# Application for URBAN DESIGN COMMITTEE Review

Project Name: Belmont Road Roundabout

Below are our response to UDC/PC recommendations:

DECEMBER 5, 2015

### PLANT SCHEDULE

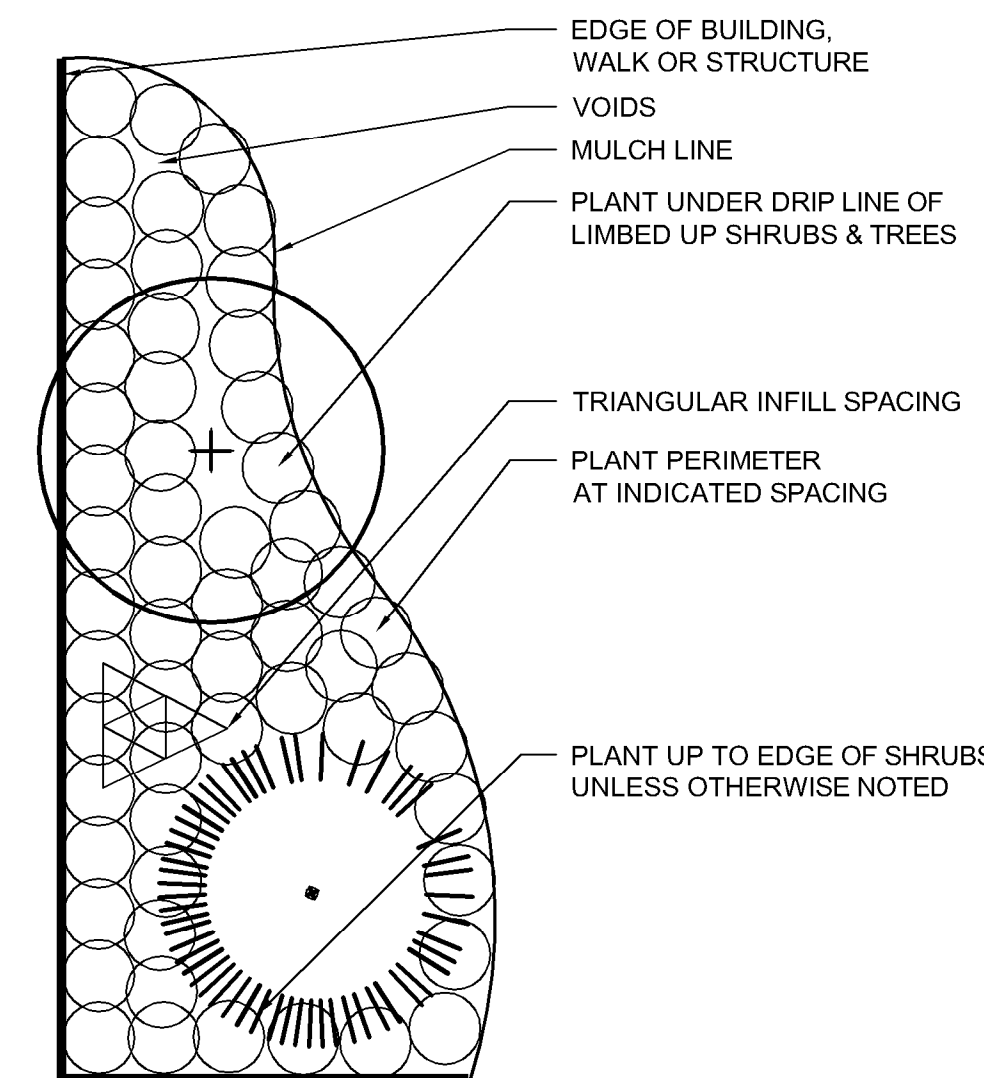
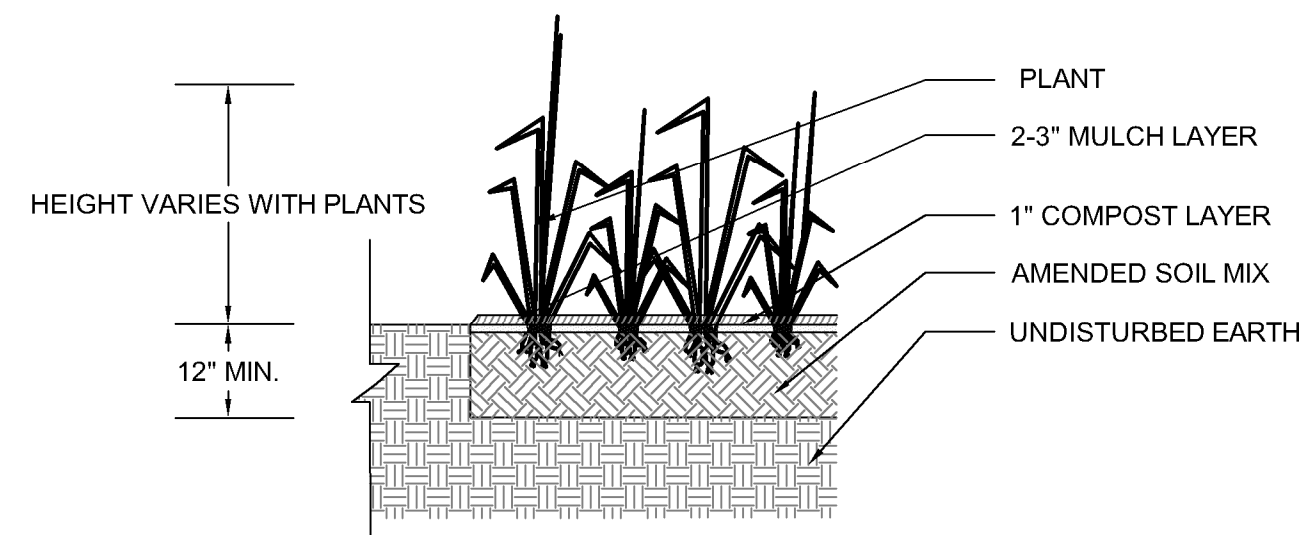
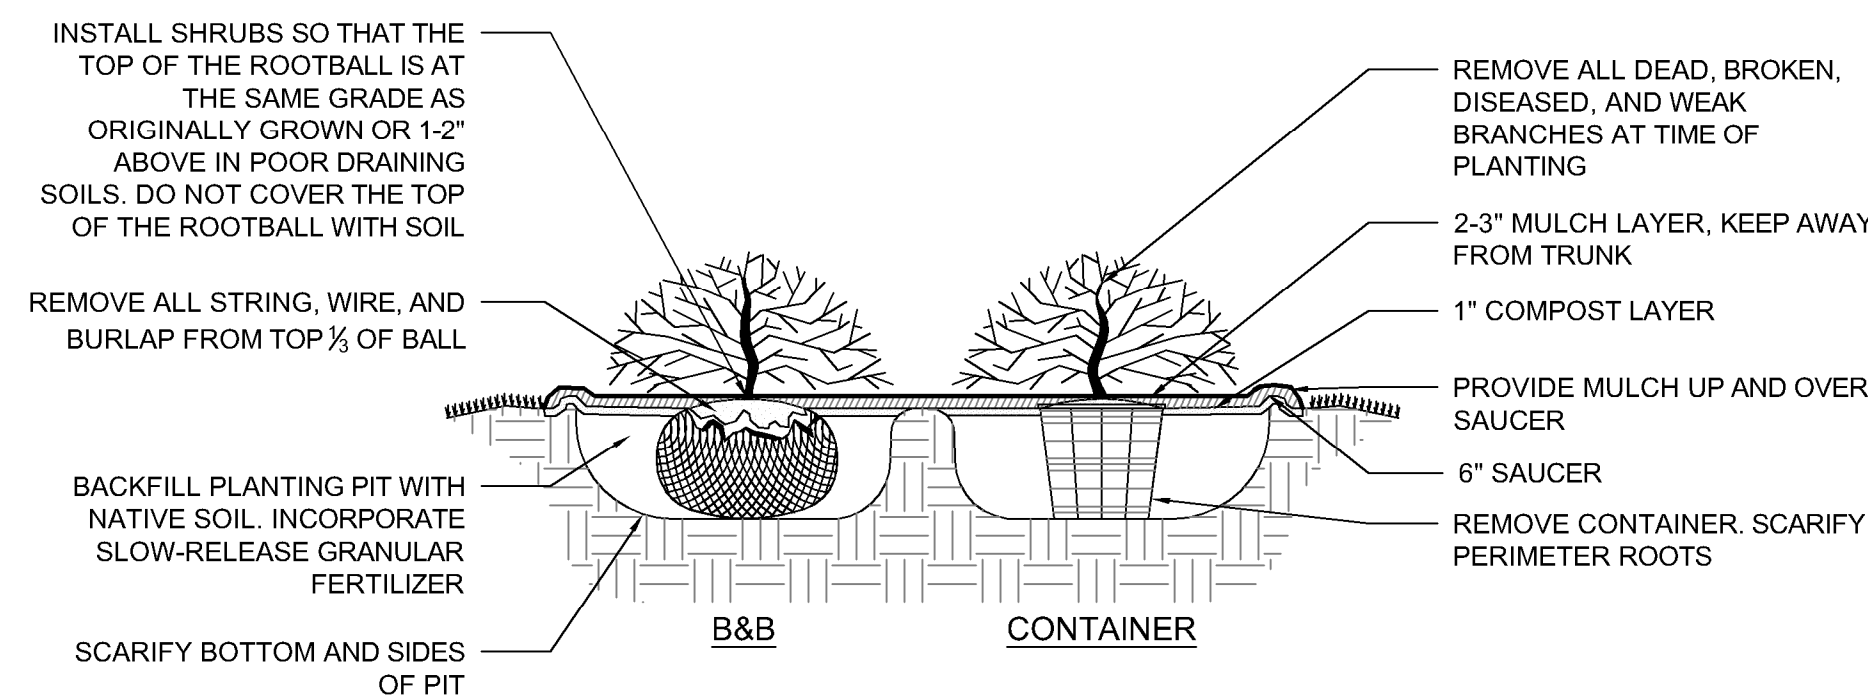
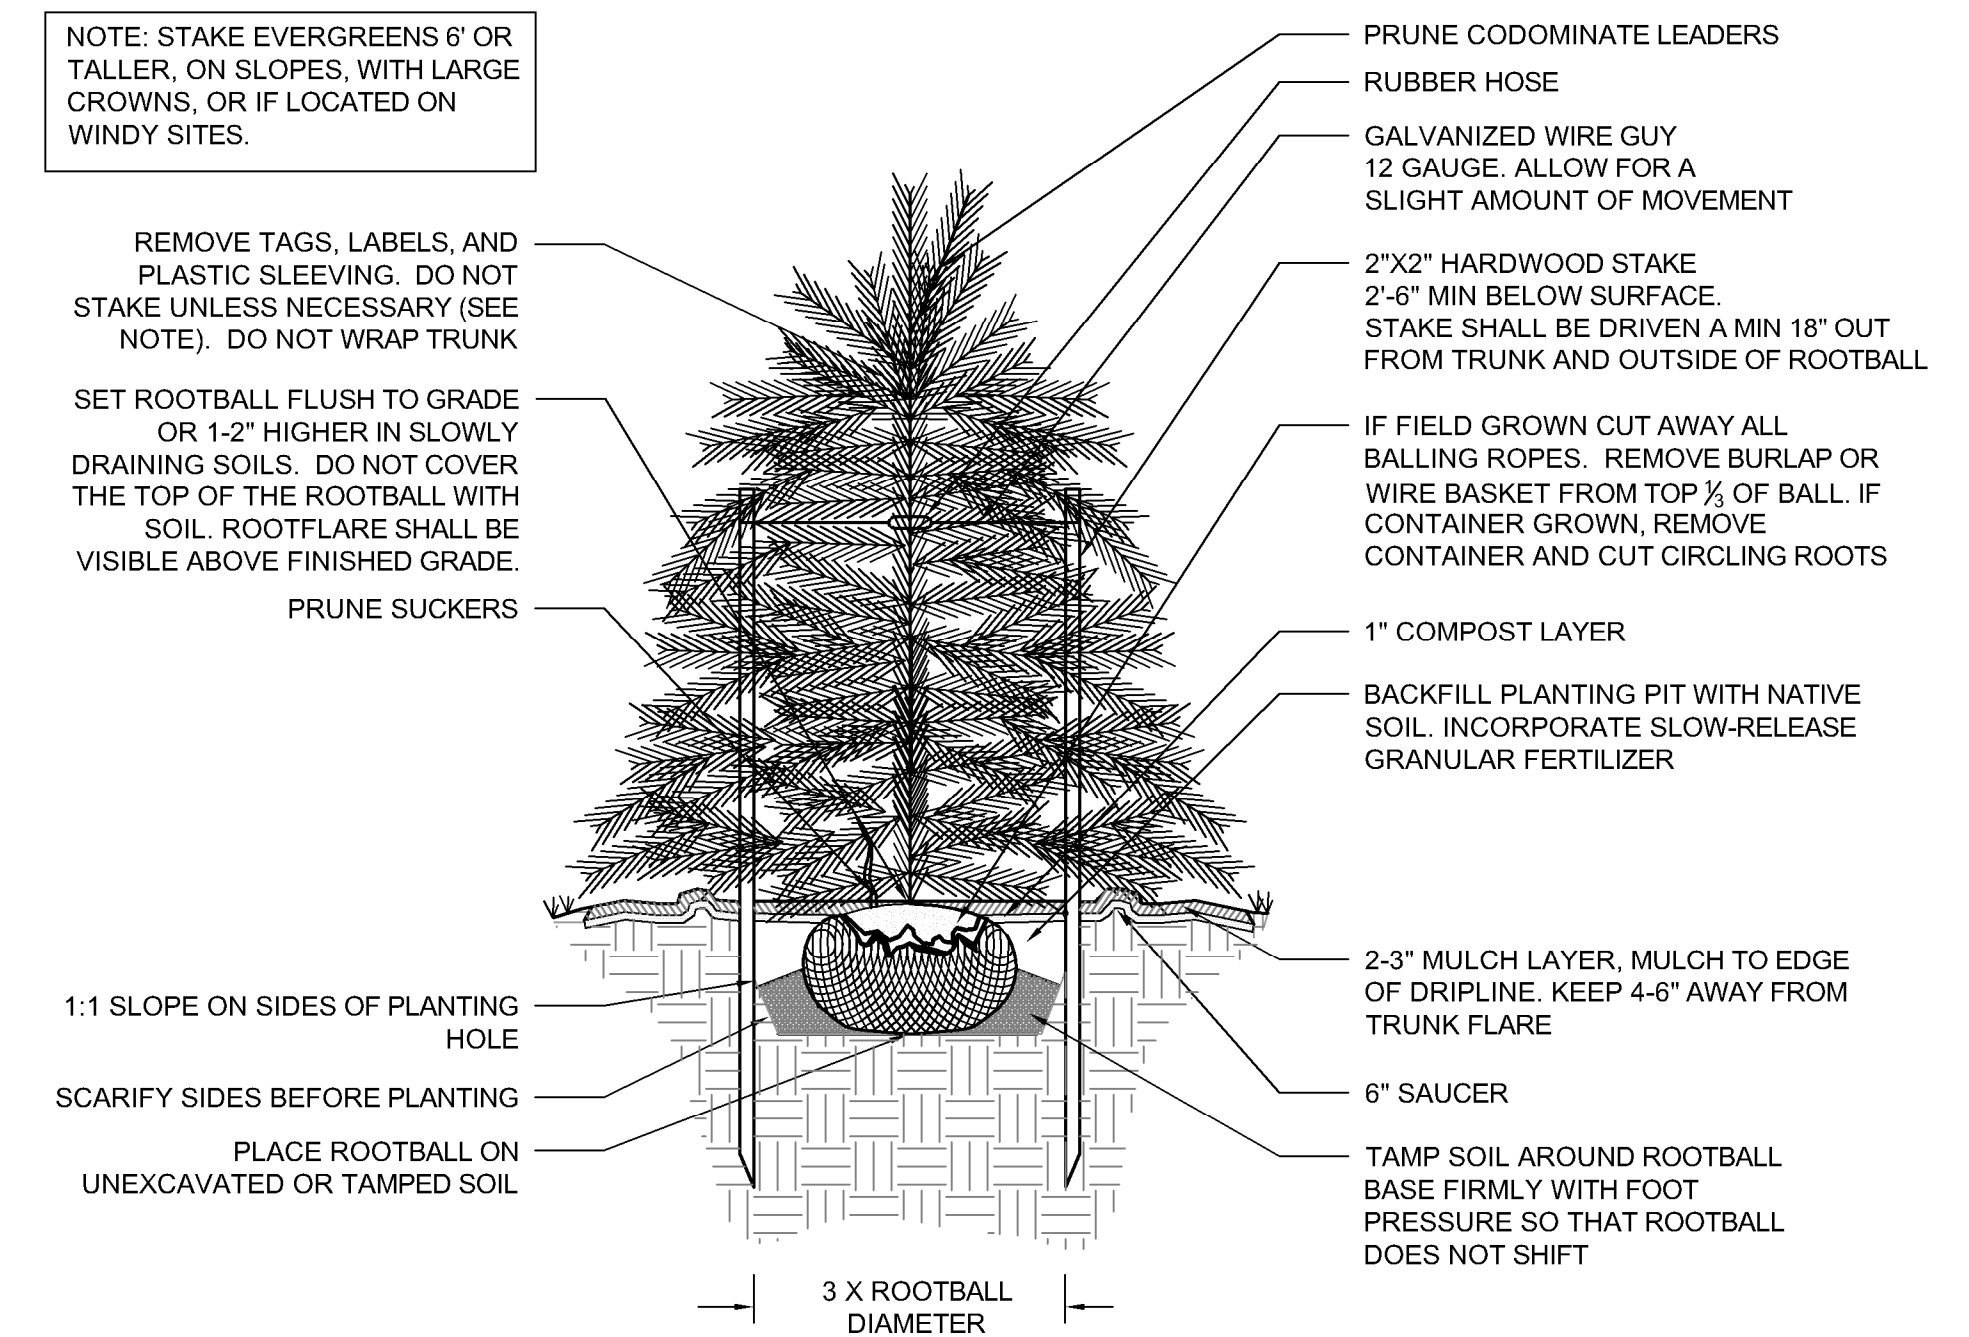
- (2) That the final plans include a landscape plan and schedule showing plant species, quantity, location and size at the time of installation. **The final plans include a landscape plan and schedule showing plant species, quantity, location and size as requested (sheets 6(1) thru 6(3)).**

DESIGN BY: N. BRASLEY	REVIEWED BY:	FIELD NOTES: PB-12, pp 12-12	SCALE: 1" = 25'	DATE: 11/06/16	SHEET: 7	DRAWING NO: 0-28661
DRAWN BY: T. HICKLEY			VERT. -

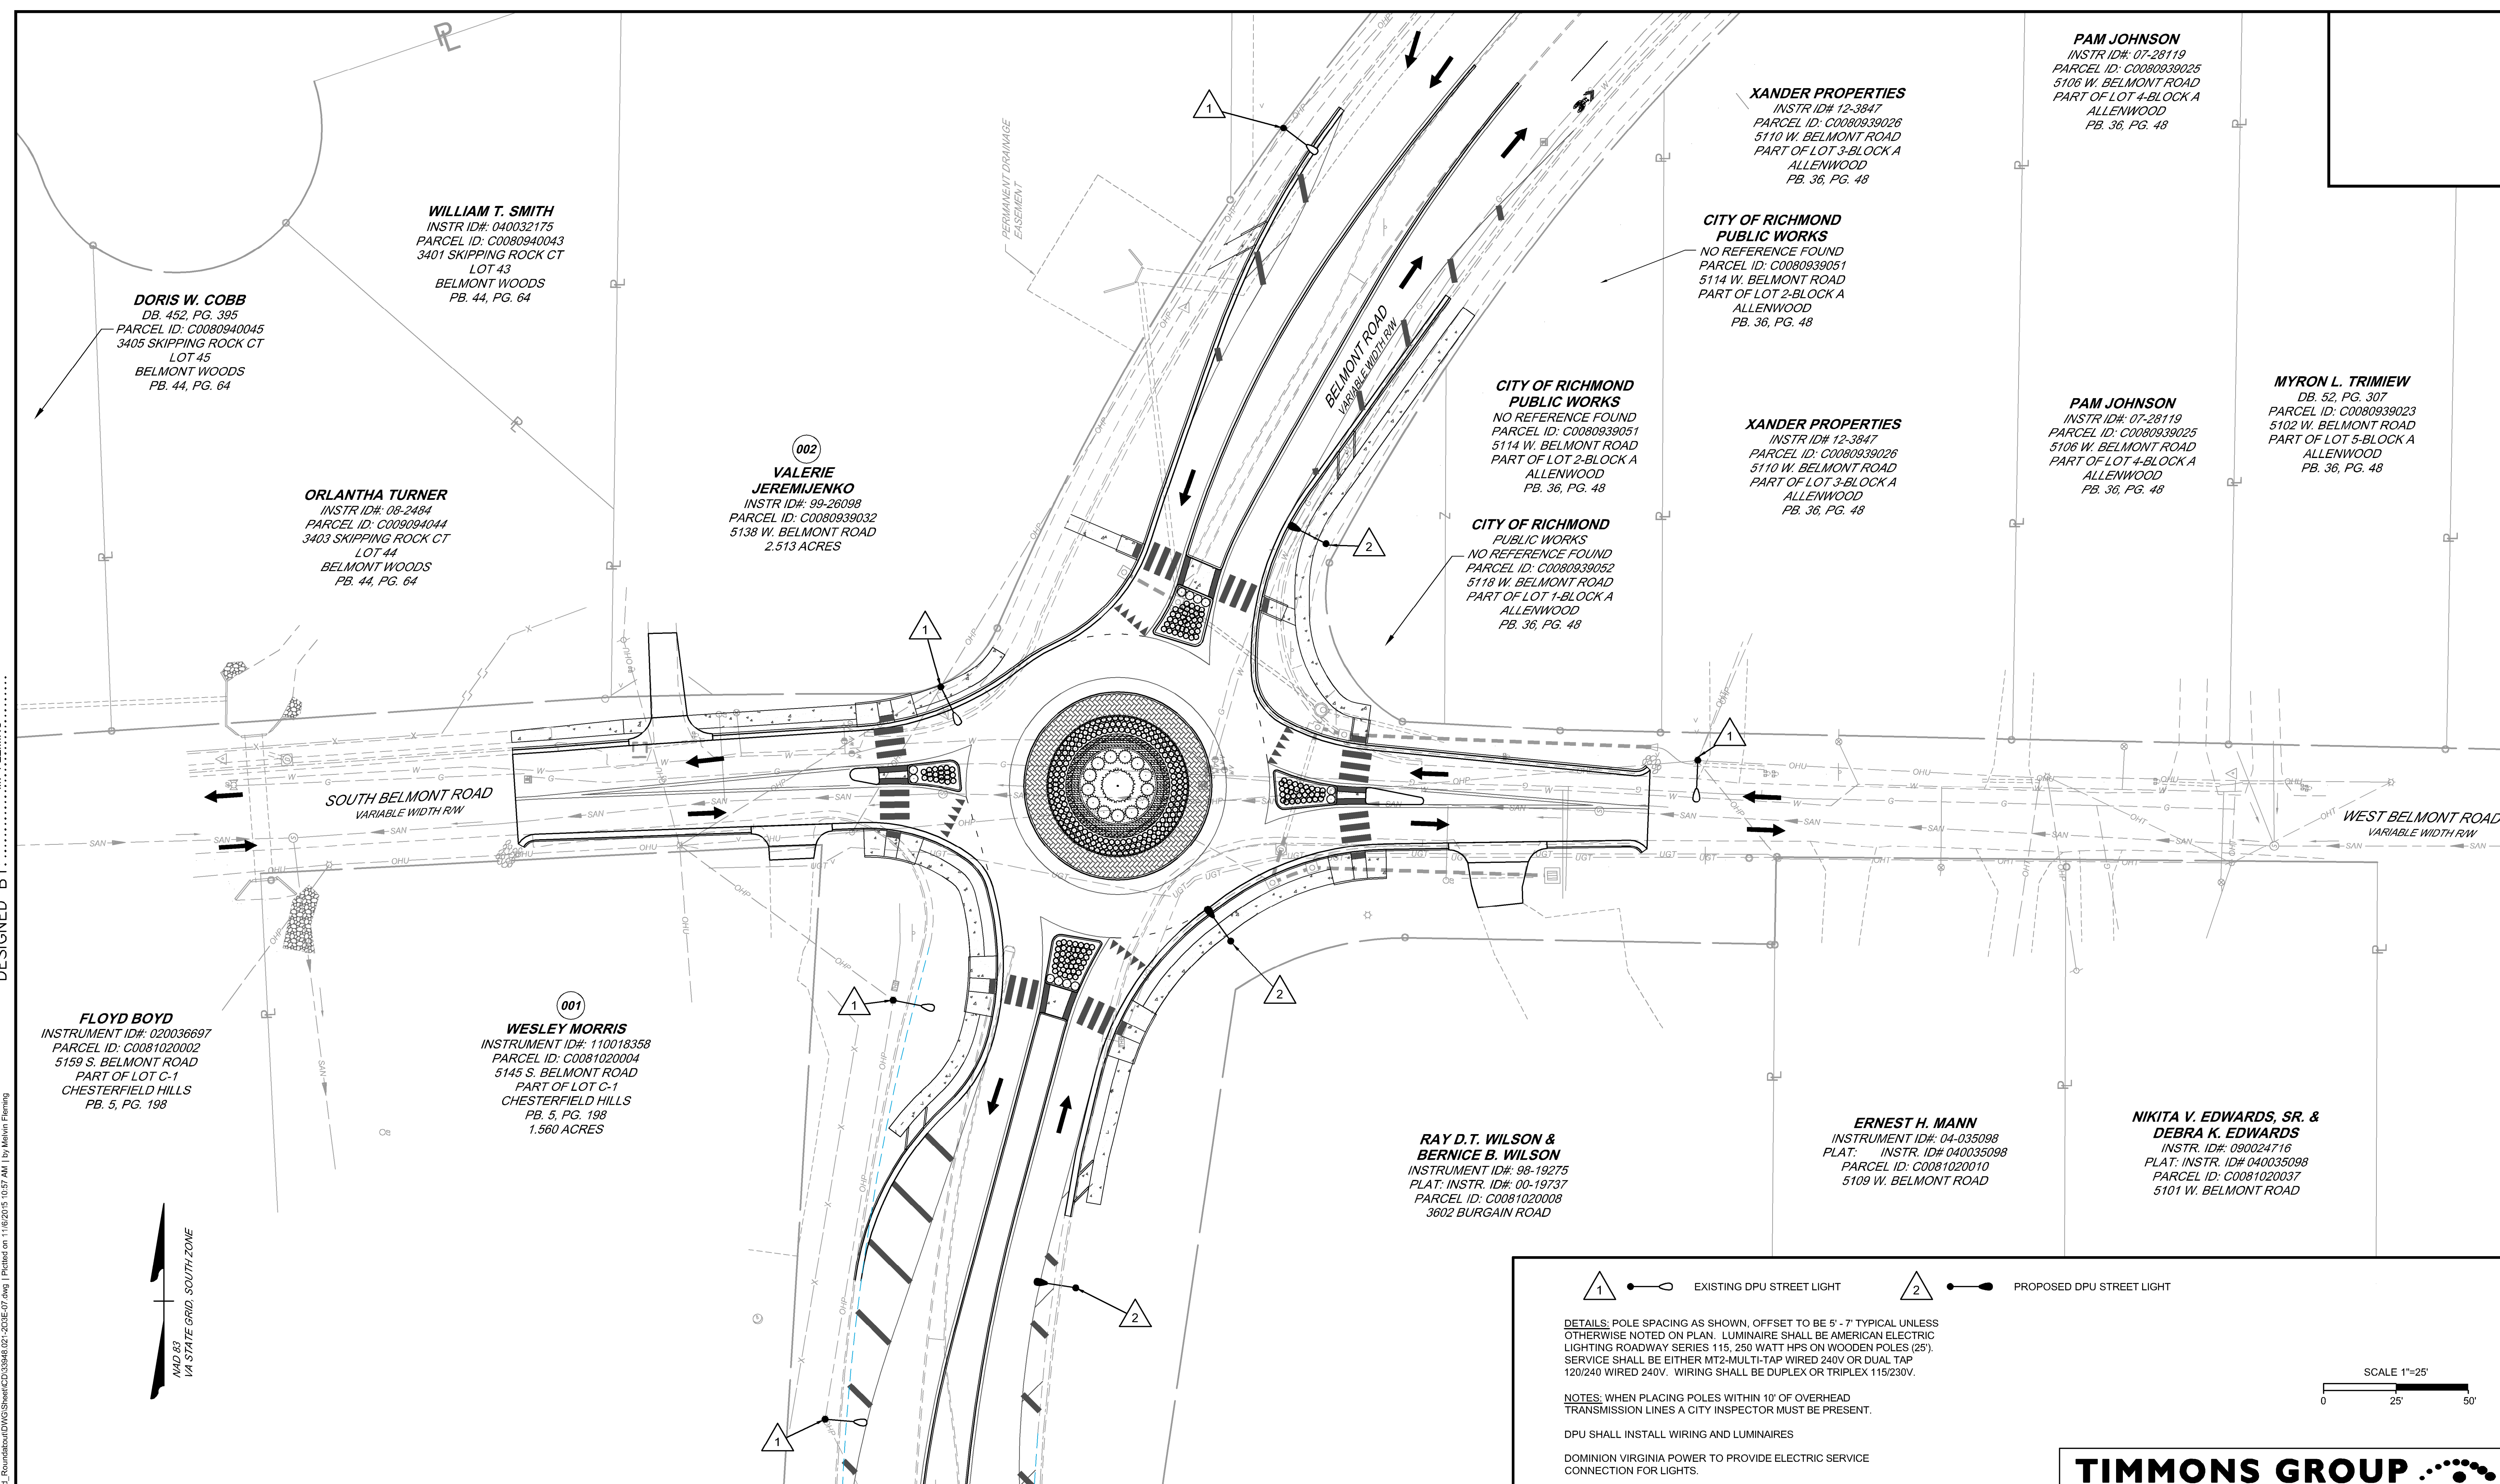
- (8) That the final plans include lighting plan, showing make, model and finish for any light pole and fixture, as well as fixture light source and color. **These final plans include a lighting plan (sheet 7) as requested. Plan includes the requested information (wooden poles with a 5'-7' arm with American Electric Lighting Roadway series 115 (250 Watt high pressure sodium luminaries)).**

DETAILS: POLE SPACING AS SHOWN, OFFSET TO BE 5' - 7' TYPICAL UNLESS OTHERWISE NOTED ON PLAN. LUMINAIRE SHALL BE AMERICAN ELECTRIC LIGHTING ROADWAY SERIES 115, 250 WATT HPS ON WOODEN POLES (25'). SERVICE SHALL BE EITHER MT2-MULTI-TAP WIRED 240V OR DUAL TAP 120/240 WIRED 240V. WIRING SHALL BE DUPLEX OR TRIPLEX 115/230V.
